SHiP Technical Proposal:

Questions from the SPSC Referees

September 23, 2015

In this document we have collected all questions posed by the SPSC Referees in their 25/5/2015 mail and our corresponding replies. Some of them have been answered in the Addendum to the Technical Proposal and are not repeated here.

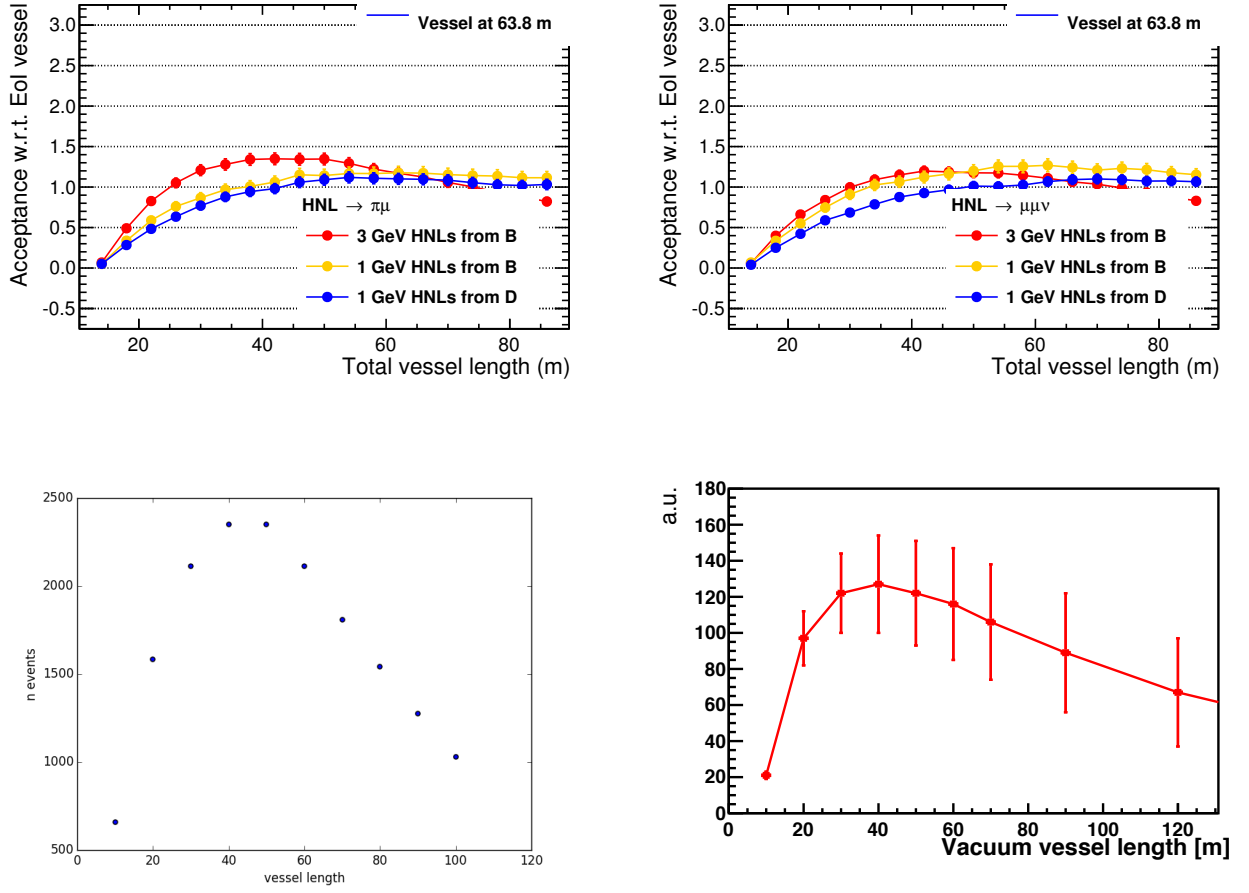
2. *To what extent are the detector layout choices simultaneously optimal for the various searches being carried out? For each of the main signals being searched for how different would an optimal detector look compared to the current design?*

The detector has been designed to be sensitive to all final states listed in Table 2.1 of the TP [3], regardless any assumption on the nature of the mother particle. However the geometrical acceptance of the detector depends on the production mechanism of the mother particle and on its lifetime, hence it is model-dependent. While fixing the transverse dimensions of the spectrometer to its maximal affordable size in terms of cost, we studied the variation of the acceptance as a function of the vacuum vessel length for three portals, neutrino, dark photon and dark scalar. The results are shown in Fig. 1. We see that the dark scalar portal would prefer a vacuum vessel ~ 10 m shorter than the baseline due to the shorter lifetime and the larger p_T of the products of b decays. More detailed studied will be performed for the Technical Design Report.

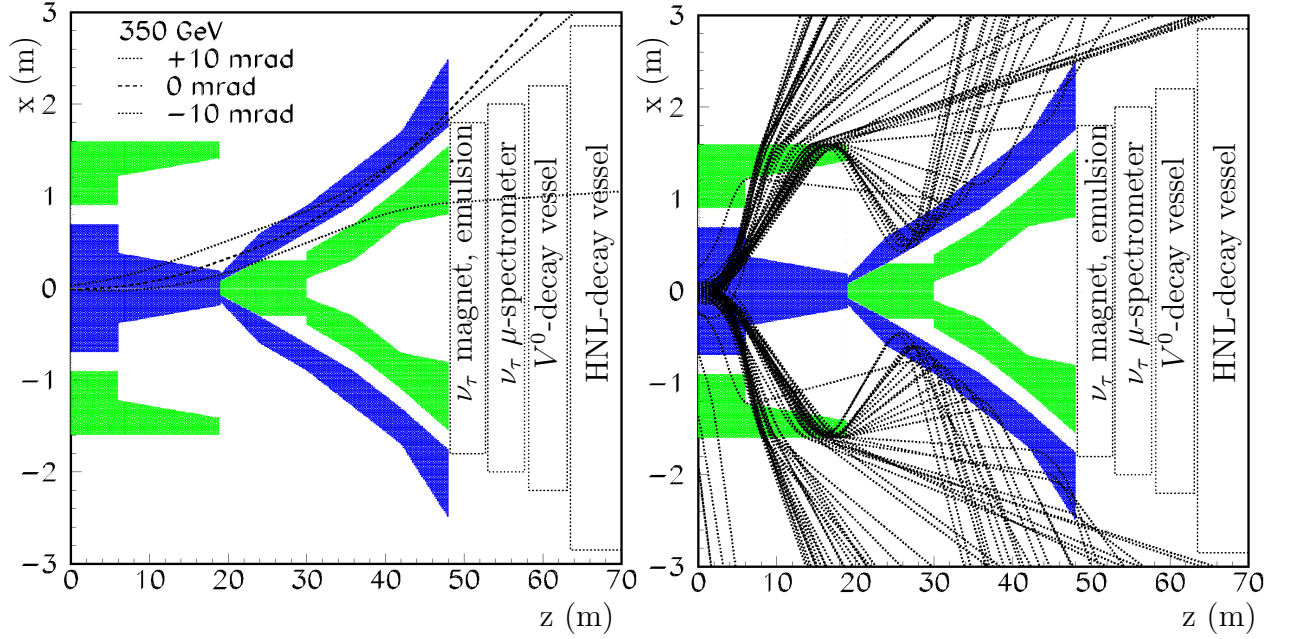
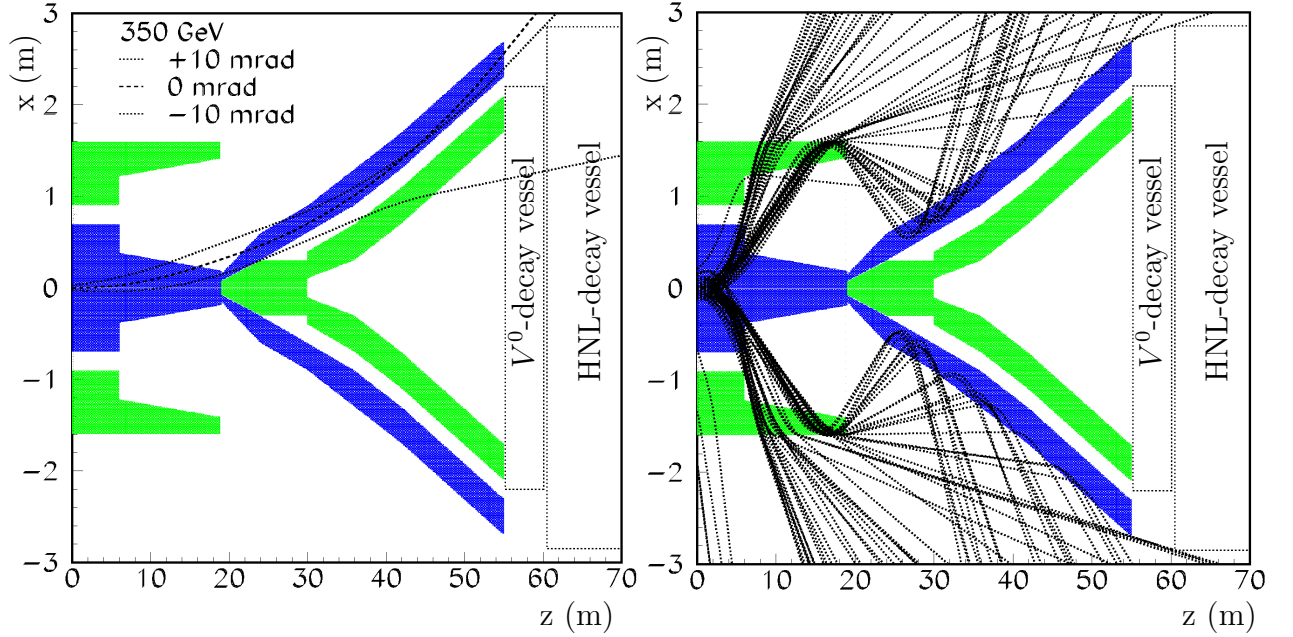
11. *Does the neutrino detector in any way diminish the sensitivity of the HS detector? If it does, have you considered moving it behind the main detector (though this would of course reduce the neutrino flux by $\sim \times 4$)?*

Figure 2 shows the layout of the active muon shield as shown in Figure 3.10 of the SHiP Technical Proposal [3], but in addition the outline of the ν_τ detector elements and the start of the vacuum vessel has been indicated.

As is shown in Figure 2 the largest momentum muons just miss the outside radius of the decay vessel which starts 63 m after the hadron stopper. In addition, the shield is constructed so that low momentum muons also just miss the decay vessel. The other detector elements fit in the region $48 < z < 63$ m, 10 m for the ν_τ detector, and 5 m for the V^0 -decay-vessel. The radii of these elements have been adapted to avoid the local muon flux. It should be noted that the existing Goliath magnet happens to have exactly the allowed width.

Now suppose we would have dropped the last condition, i.e. do not foresee 10 m of space for the ν_τ detector, and try to move the hidden particle decay volume as close as possible to the hadron stopper. This requires that the largest momentum muons pass through more field, i.e. the active shield has to be extended. Figure 3 shows the layout of such an active muon shield. The shield has been extended by an extra 7 m to bend the 350 GeV muon out to a radius of 2.85 m, 5 m downstream of its end. The shield cost increases by an estimated 15-20 %. This allows the hidden particle decay volume to start at 60 m, leaving the required 5 m for the V^0 -decay-vessel.

Hence, the hidden particle spectrometer moves from a distance of roughly 120 m to 117 m from the target. The emulsion of the ν_τ detector moves from 57 m distance from the target to roughly 130 m. The negligible gain in acceptance for hidden particles should be compared to a factor 3.5 to 7 loss in acceptance depending on the neutrino flavour. In addition, the muon spectrometer of the ν_τ detector acts as active last material before the hidden particle spectrometer by tagging any ν interaction, and this feature to tag a background source would be lost, with a corresponding background increase.

Figure 4: Sketch of muons back-scattered from the walls of the tunnel containing the first magnet of the active muon shield: with lateral dimensions of 3.5 m as in the TP (left) and of 20 m (right).

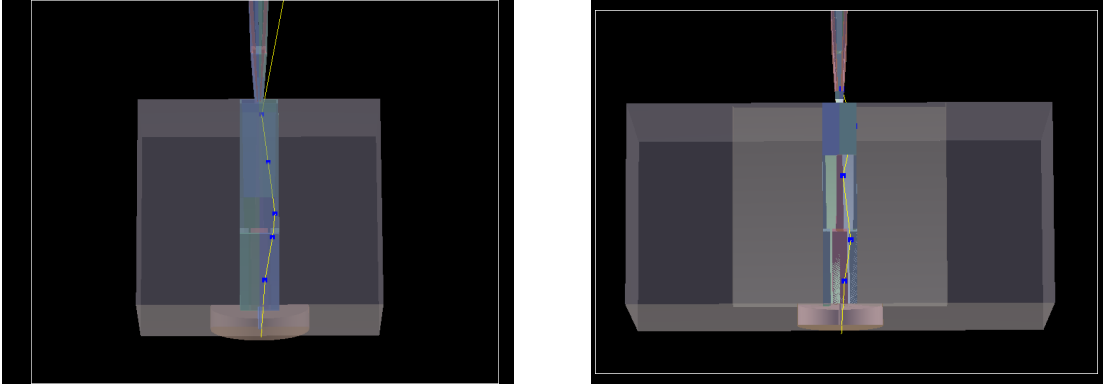
1. *There will be large numbers of muons to be deflected. Can a non-vanishing number of them be scattered back into the region of interest by the material in the active-shield area?*

This answer also addresses part of question A1, i.e. how does the muon rate scale with the cavern size. All the material in the active shield area including the cavern walls are in the simulation, and back scattering is simulated. In fact, a significant part of the low energy background originates from muons scattering in the walls of the small tunnel containing the first magnet (Fig. 4, left). A further optimization done after submission of the TP shows that this could be reduced by about a factor 10 by making the first part of the cavern as wide as the rest (Fig. 4, right). Work in progress, see also answer to D.2

Figure 5: Overall hit rates seen by various detectors during 1 sec spill of 5×10^{13} pot.

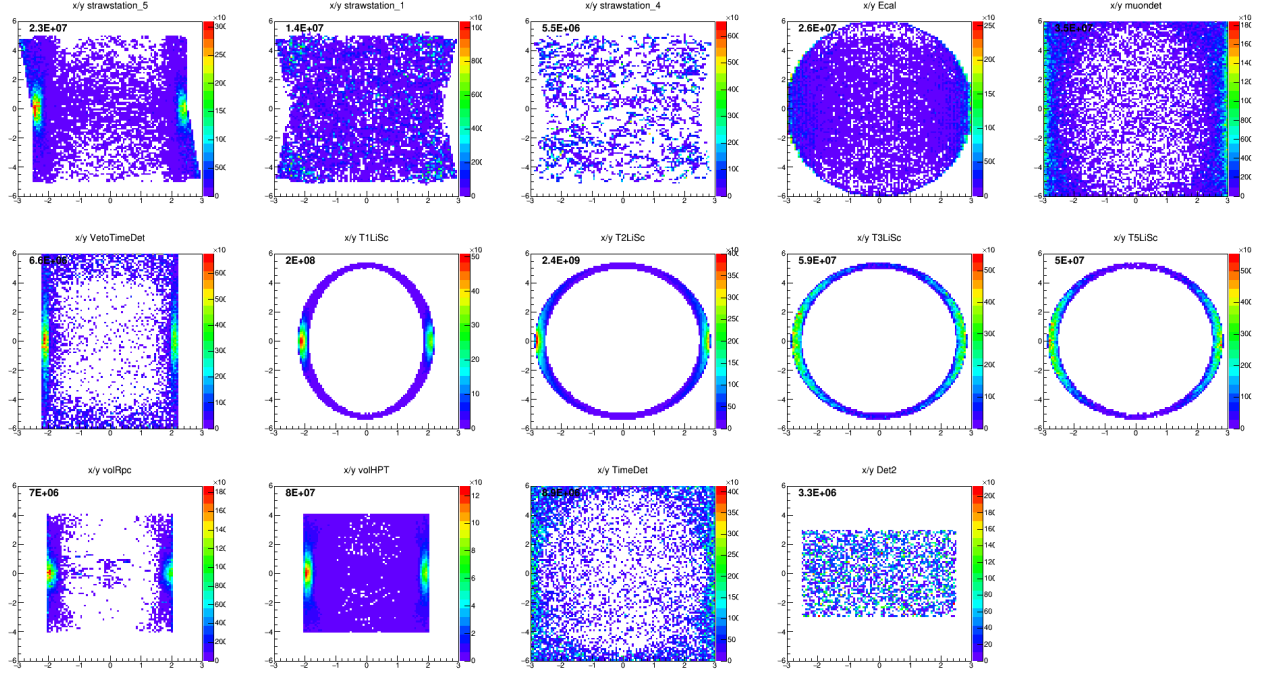
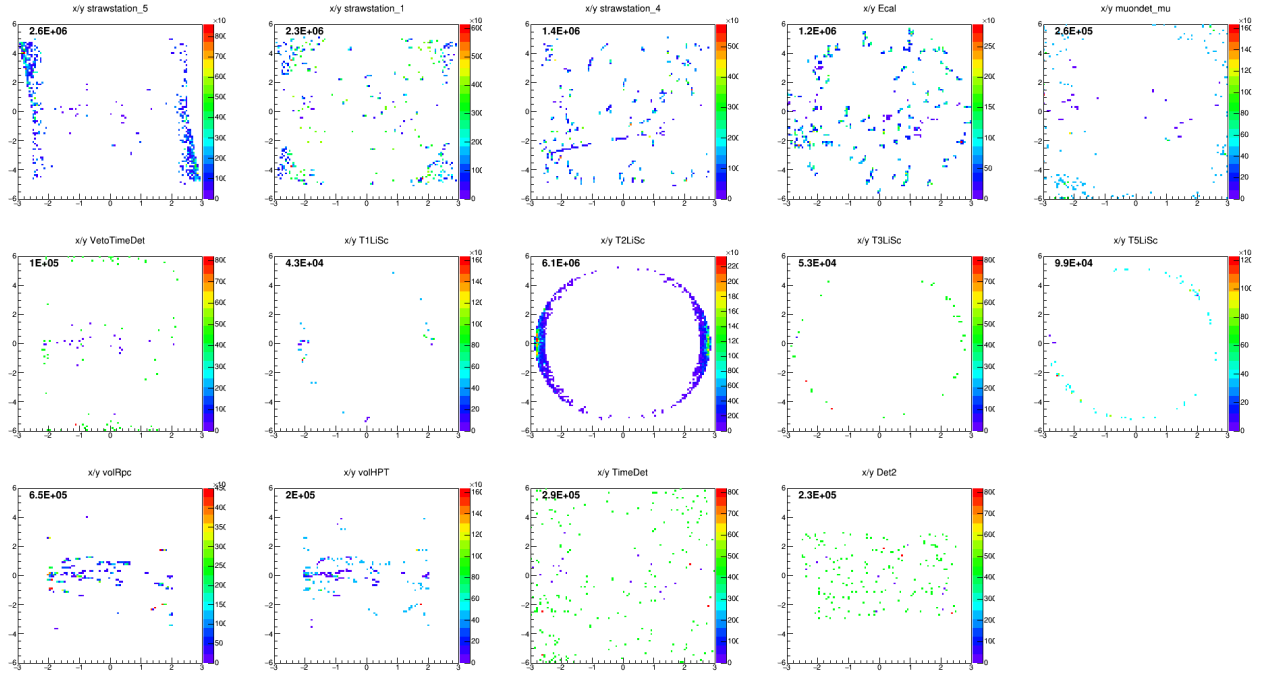
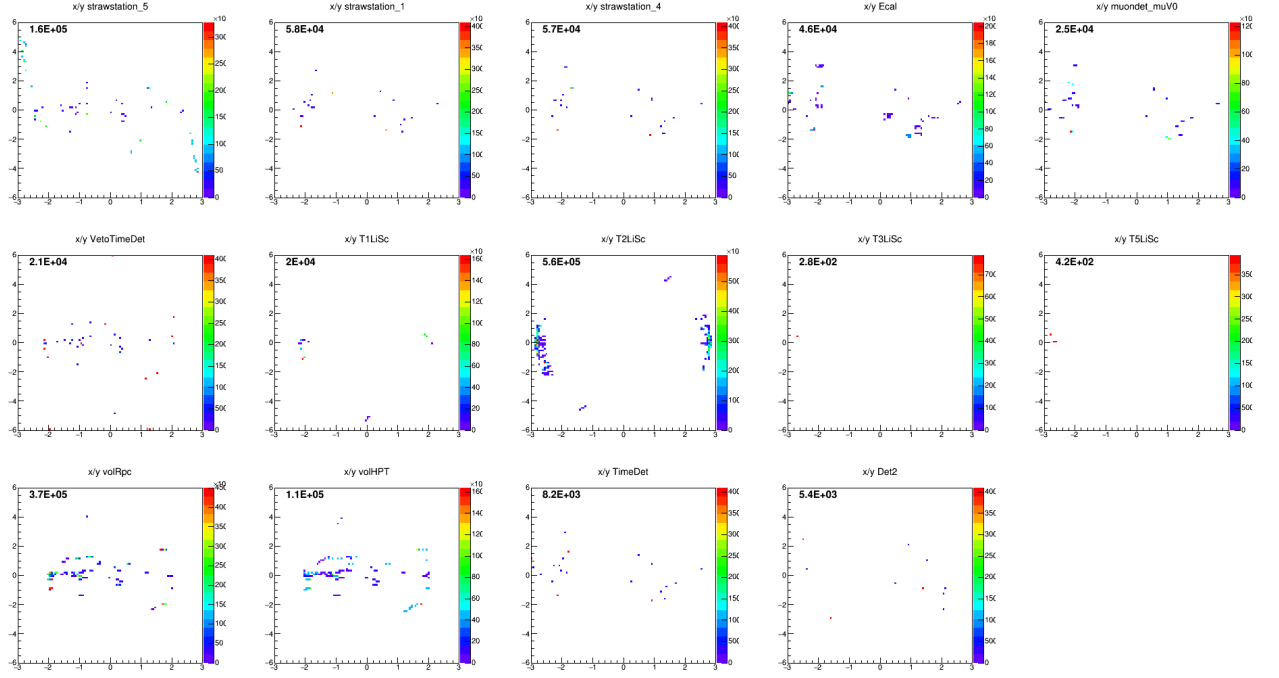
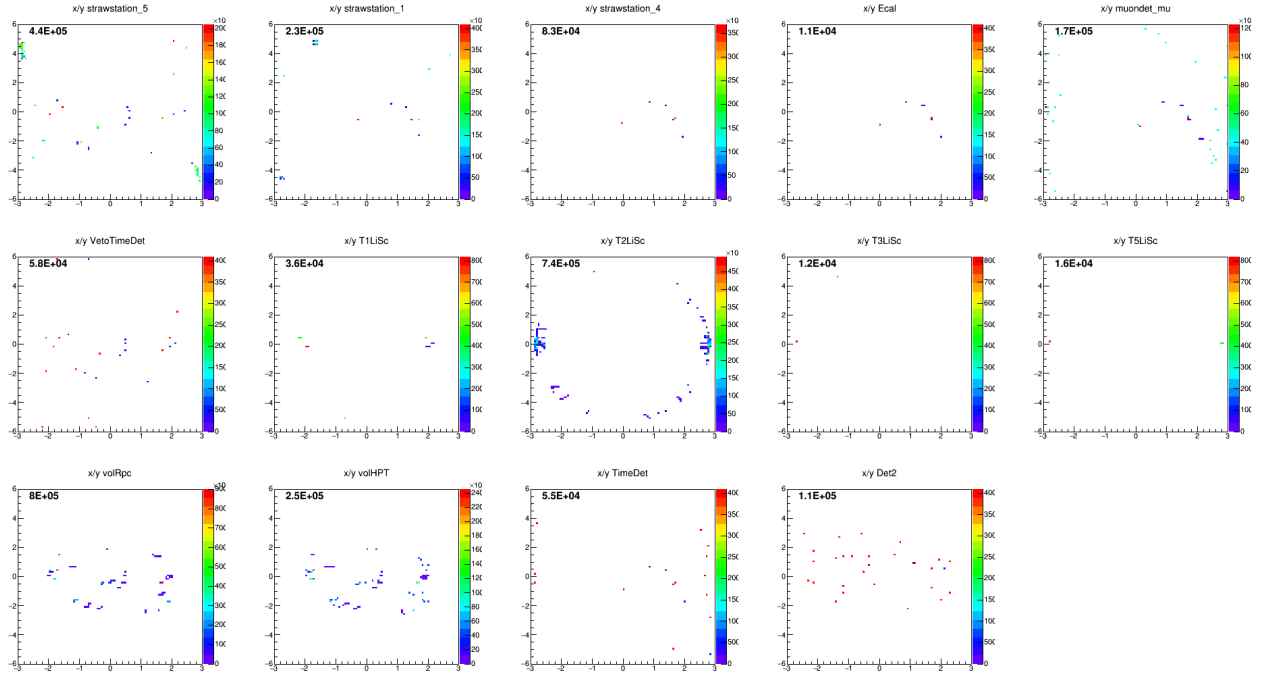
2. *We have some difficulty reconciling the different numbers for muon rates at different parts of the detector (e.g. 4 kHz/m² at neutrino detector, 100 kHz at upstream veto tagger and 7 kHz in the spectrometer). It would be useful to have $x - y$ plots of the muon flux at the various positions of these detectors, and the incident rates summarized in a table like 4.12.*

Here we have to distinguish between hit rates, like 100 kHz at upstream veto tagger, and reconstructed track rates, like 7 kHz in the spectrometer. Different hit rates for different detector positions are shown in the following figures: Figure 5 shows the overall hit rate for various detectors, Fig. 6 shows the hit rates induced only by muons, Fig. 7 shows the hit rates induced by muons with $p > 3$ GeV/c. The numbers in each plot correspond to the integrated rate of hits / spill for $N_{\text{pot}} = 5 \times 10^{13}/\text{spill}$. It is worth noticing that a large fraction of the hit rate induced by muons originates from muons back-scattered by concrete walls in the small tunnel containing the first magnet of the active muon shield. Figures 6 and 8 show the hit rates induced by muons assuming a lateral dimension of the tunnel of 3.5 m (as in the TP) and 20 m (as the rest of the cavern), respectively: the hit rate decreases by a factor of ten. Detailed studies will be performed for the Technical Design Report.

Figure 9: Neutrino tomography of the experimental setup. The points define the position of the potential interaction with the experimental setup of neutrinos originating from the target, the density of points reflects the material density.

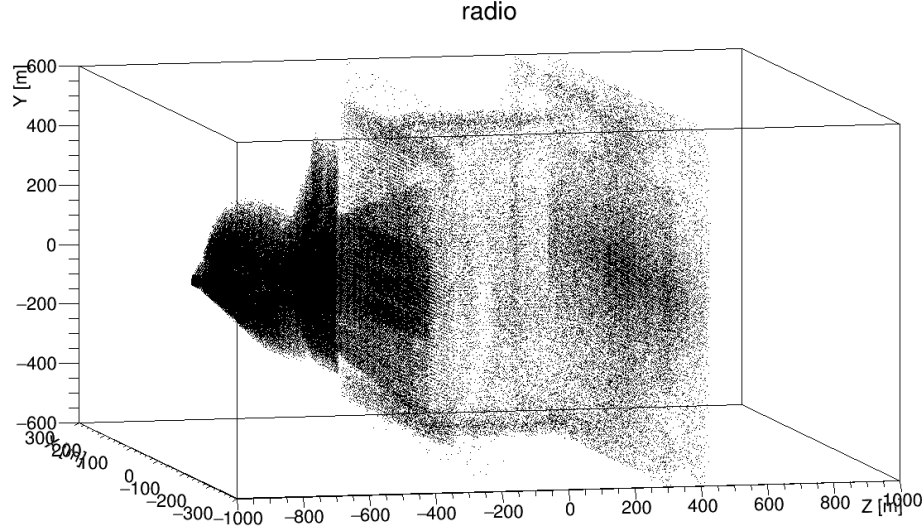
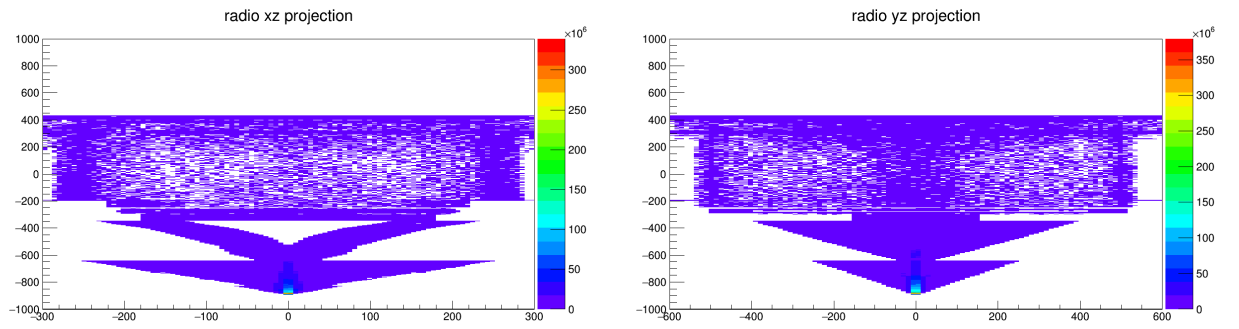
3. *Similar plots would be useful for the neutrino flux.*

Figure 9 shows a neutrino tomography of the experimental setup and Fig. 10 the xz and yz projections. The points define the position of the potential interaction with the experimental setup of neutrinos originating from the target, the density of points reflects the material density.

Figure 11: Left plot: SHiP data (red) are reported in the (x, Q^2) plane together with all the data used by the NNPDF group (grey). Right plot: SHiP data in the same plane with (blue) and without (grey) the selection applied.

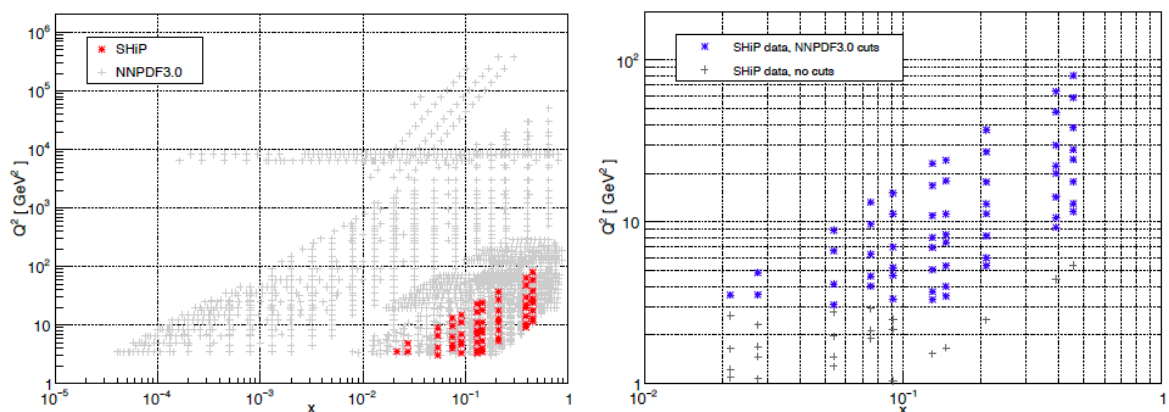
3. *For the proton strangeness measurements: there are a number of potential systematic effects, such as nuclear corrections, higher twist effects, etc. How might these uncertainties affect the strangeness extraction? And is it possible to have a plot of the distribution of data over (x, Q^2) (e.g. kinematic plane with some colour-coding for statistics as a function of x, Q^2) to help judge the impact of cutting out the low- Q^2 region?*

In order to reduce the impact of higher twist effects, the standard cuts applied in the NNPDF analyses have been imposed to the generated pseudo-data. These include a cut on Q^2 ($Q^2 > 3.0 \text{ GeV}^2$) and the invariant mass of the final state ($W^2 > 12.5 \text{ GeV}^2$).

In Ref. [5] it has been shown that the impact of nuclear corrections on PDF determinations based on the NNPDF methodology is negligible in comparison to the typical uncertainties of the scattering data of heavy, approximately isoscalar, targets.

For this reason no nuclear corrections have been applied to the data. In view of the higher precision expected for the data coming from the SHiP experiment, this conclusions should, in principle, be reassessed. In this preliminary study we have not performed any investigation of the impact of these theoretical uncertainties on the strangeness extraction. We defer this analysis to a future study where this question will be addressed by performing a number of fits applying different Q^2 and W^2 cuts and different models for nuclear corrections.

Figure 12: The muon rate after the target and absorber is shown for the different target configurations (left) and as a ratio of different configurations (left). The difference of the other configurations with respect to the baseline design with tungsten is $< 20\%$.

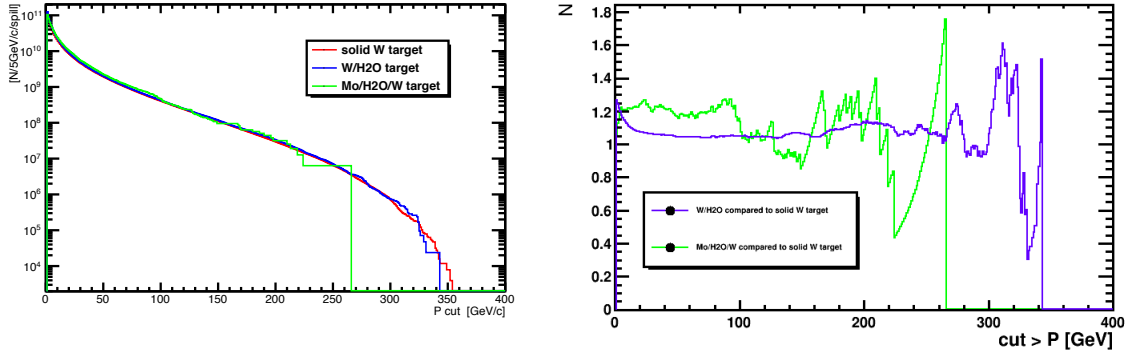
5. *Fig. 5.4 would be useful to see this as a ratio, particularly at low momentum where differences are most significant, given the various detector efficiency dependences on momentum.*

Figure 12 shows the original Fig. 5.4 of the TP (left) and the ratios of the muon rates for different target configurations (right). The difference of the other configurations with respect to the baseline design with tungsten is $< 20\%$. However it should be noted that the momentum spectrum of muons reaching the sensitive detectors is very different compared to the momentum spectrum shown in this figure.
